Technical Service Bulletin

MODEL(S) AFFECTED: T300/T300e Walk-behind Scrubber

SUBJECT: Disabled vacuum motor due to wire harness failure at squeegee lift bracket switch. Over time, as the squeegee lift bracket pivots from side to side, the squeegee lift bracket switch wiring may weaken and eventually break.

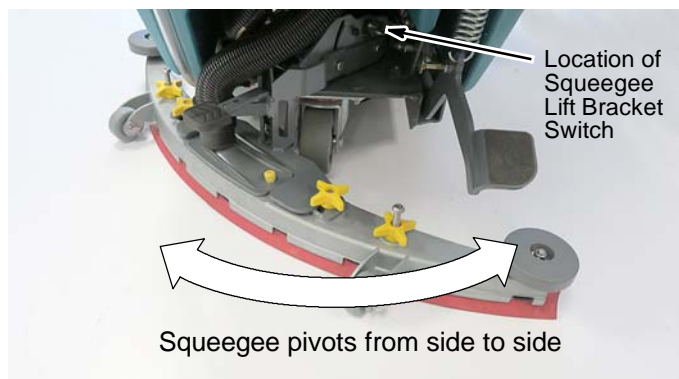
PURPOSE: To repair or prevent wire harness failure, order retrofit kit 9016739. The kit is designed to retain the squeegee switch connector wire harness as shown below.

NOTES: **Warranty Information:** Standard warranty terms apply.
A manufacturing change to add the retaining bracket and to lengthen the squeegee switch harness will be implemented into production in the near future.
